# The International Standard on Solid-State Relays (IEC 62314, Ed. 1)

## Critical Review

Vladimir Gurevich, Ph. D.,

Fig. 1. Solid-state relay rated for both AC and DC loads

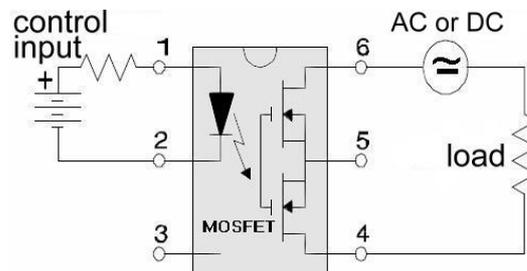
1.1. In this section I focus on the scope of the standard. According to the standard the scope is limited to solid-state relays with rated voltages of up to 750V and AC currents up to 160A. In the remarks it is noted that requirements for solid-state relays with DC output circuits are under consideration. These remarks are a little bewildering: what is the necessity to release a standard on the solid-state relays that covers only a small fraction of the solid-state relays that are available in the market today? In fact, many types of solid-state relays with the output element in the form of two powerful MOSFET transistors can switch both AC and a DC current, Fig. 1. The absurdity of the situation becomes apparent when one considers that only half of such relay (AC) is covered by standard IEC 62314, while the other half of the same relay (DC) is not covered.

Even the standard itself (in note to Section 3.1.8) recognizes that “the same solid-state relay may be ... rated for both a.c. and d.c.”

Fig. 5. Solid-state relay controlled by mechanical switch (push button, for example)

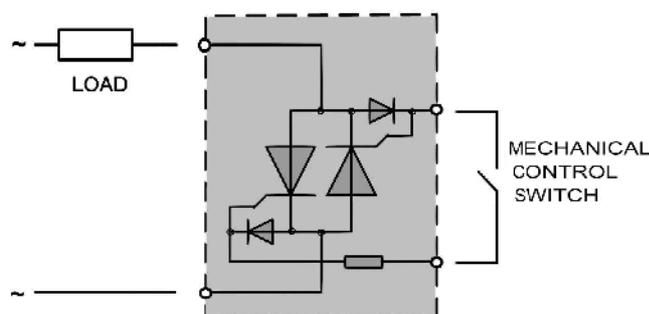
Apparently, from the definition given in the standard, the principle of construction of an input control circuit stipulates only that it should not contain any moving components, while the output power switching circuit is not characterized in any way. Therefore, under the definition given in the standard, any solid-state relay may be a suitable device that consist semi-conductor input sensing transducer (optocoupler, for example), the semi-conductor amplifier and the output electromagnetic relay. On the other hand, well-known relay design in which it is embedded epoxy resin, includes a semi-conductor output switching element (the thyristor, the transistor) controlled by a reed switch. The control coil of the reed switch forms a magnetic control circuit of the relay. The relays based on this well-known principle are widely used [2, 3]. But the reed switch contains internal moving components, so, such a device cannot be referred to as a “the solid-state relay” in spite of the fact that it meets to all requirements of standard IEC 62314 except the definition of the term: “the solid-state relay”. Another example is a unit containing two back-to-back connected power thyristors (the natural solid-state switch) controlled by external push button, Fig. 5, is this a “solid-state relay” or not?

In our opinion definition of the term “solid-state relay” presented in IEC 62314 is not correct and requires revision with an orientation to the "solid-state" character of the output element that is carrying out switching of an external circuit (load) instead of to the design of a control circuit.

Fig. 6. Examples with different properties for same insulation material which both suitable for the “solid insulation” definition

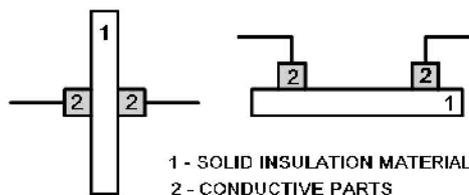
Secondly, both examples shown in Fig. 6 are suitable for the “solid insulation” definition but the properties of this insulation for the same insulating materials and same conditions are absolutely different. It is not clear what the necessity was to introduce this term into the standard and to give it a special interpretation. In our opinion, the term and the definition are absolutely unnecessary in a standard on solid-state relays.

Fig. 7. Solid-state relay with incorporated protective element which can be disconnected from the main terminals for the period of tests due to removal of external links (bridge).

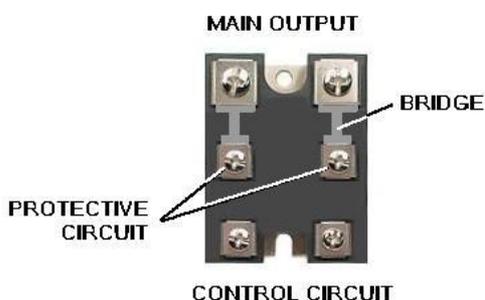
The problem arises because many constructions of solid-state relays contain built-in internal structures for overvoltage protection (more often, varistors) which, naturally, have lower pickup thresholds than the installation protected by them (that is, the solid-state switching element of the solid-state relay). Thus, short-term, step-up pulses of a voltage on the relay terminals at tests will lead to pickups of this protective element. The long duration, for example, approximately one minute, of the step-up voltage during the tests will lead to the destruction of a protective element. Thus, it is impossible to perform normal withstanding voltage tests for many solid-state relays constructions.

The problem may be solved by changing a principle of connection of a protective element to output relay terminals at which this protective element could be disconnected from the terminals for the period of tests due to removal of external links, Fig. 7. Such a change in the design of the solid-state relay would allow solving a problem of tests and should, in our opinion, be introduced into the standard as the obligatory requirement to construction of the solid-state relays.
